# YANKEE ATOMIC ELECTRIC COMPANY

October 25, 1972

Reference: License No. DPR-3(Docket No. 50-29)  
Proposed Change No. 102

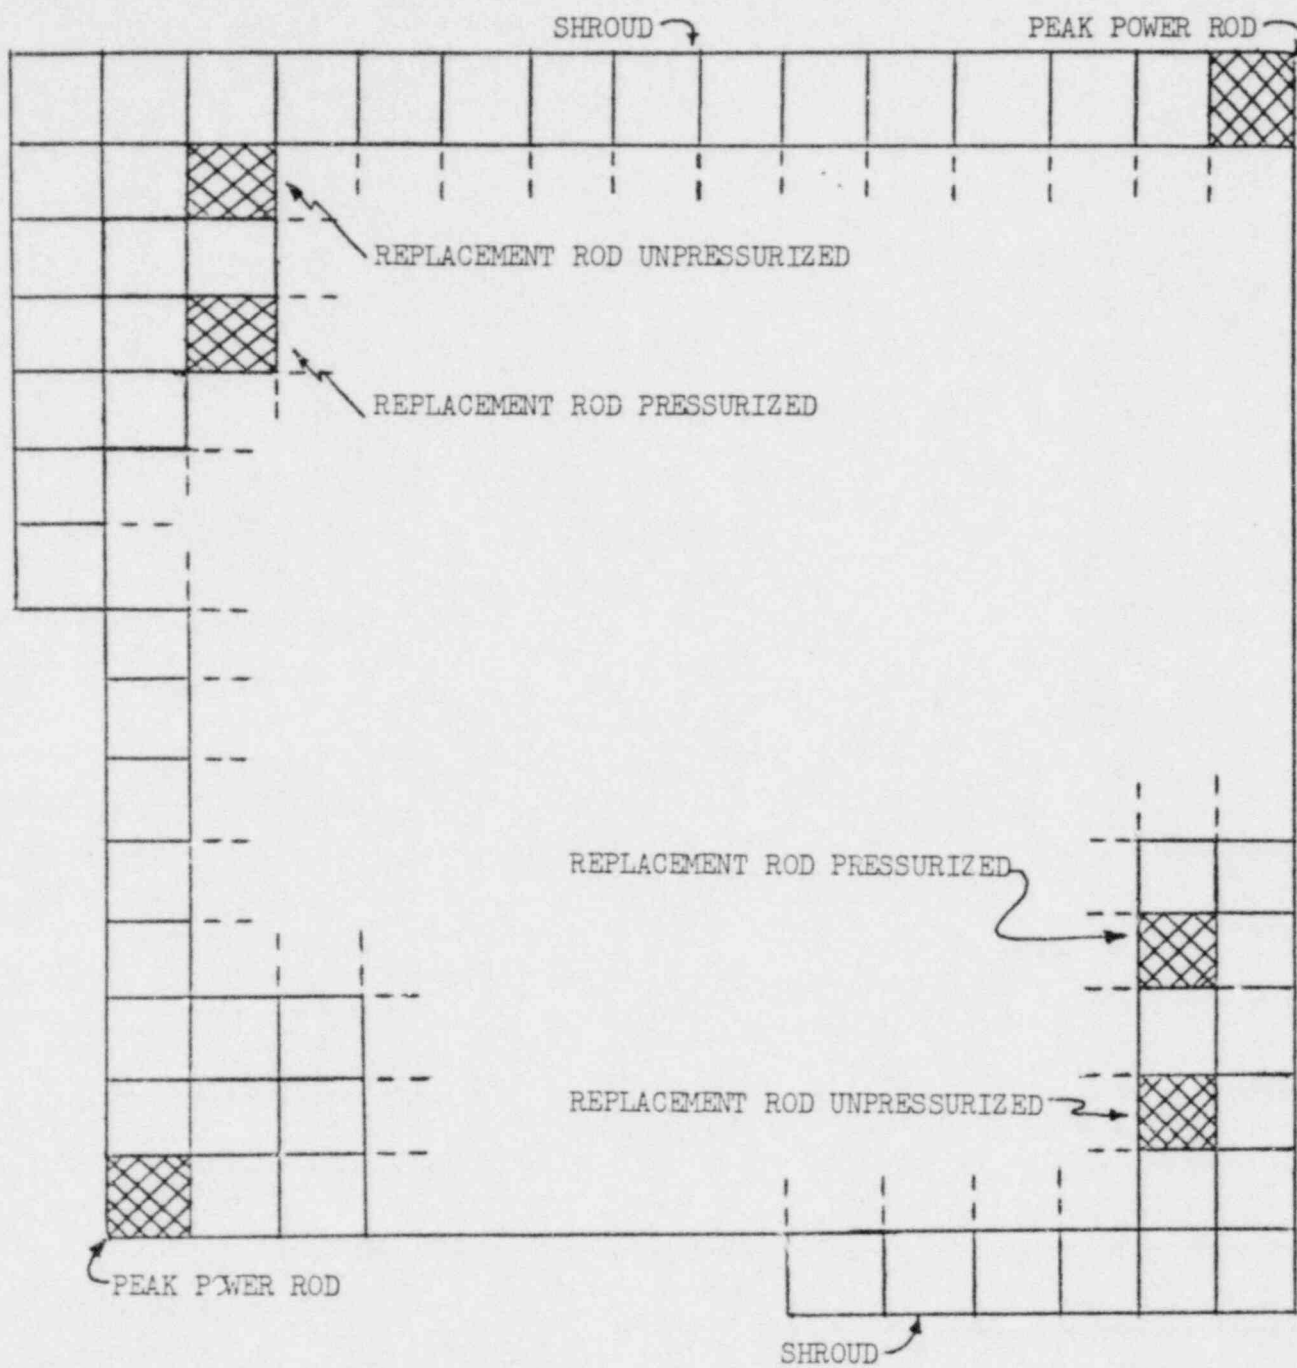
The four Zircaloy clad fuel rods, originally enriched to 4.0 W/O shall be removed from fuel assembly No. B-436 located in Core X position J-7. The four fuel rods shall be removed from corners of the fuel assembly not located adjacent to control rods. Although the fuel assembly was primarily constructed with unpressurized fuel rods, two of the removable fuel rods were pre-pressurized. Two fuel rods, one pressurized and one unpressurized have a burnup of approximately 3200 MWD/MTU, and two fuel rods, one pressurized and one unpressurized have a burnup of approximately 4155 MWD/MTU. The four fuel rods to be removed will be replaced with four mechanically identical Zircaloy clad fuel rods (two pressurized and two unpressurized) with an enrichment of 3.5 W/O as shown in Figure 1. This enrichment is approximately equal to the enrichment of the fuel rods, at this burnup, to be removed.

The nuclear analysis, to show the effect of replacing the four fuel rods, was performed using two dimensional PDQ calculations. This analysis showed that the peak fuel rod, in the vicinity of the replacement rods, increased 1 to 2%; however, this peak was approximately 27% below the peak fuel rod in the assembly. (The peak fuel rod in the assembly corresponds to the predicted value given in Table 102-2 of Proposed Change No. 97). Insertion of the four 3.5 W/O Zircaloy clad fuel rods did not affect the peak fuel rod in the assembly; thus, all inputs to transient and accident analysis would not change.
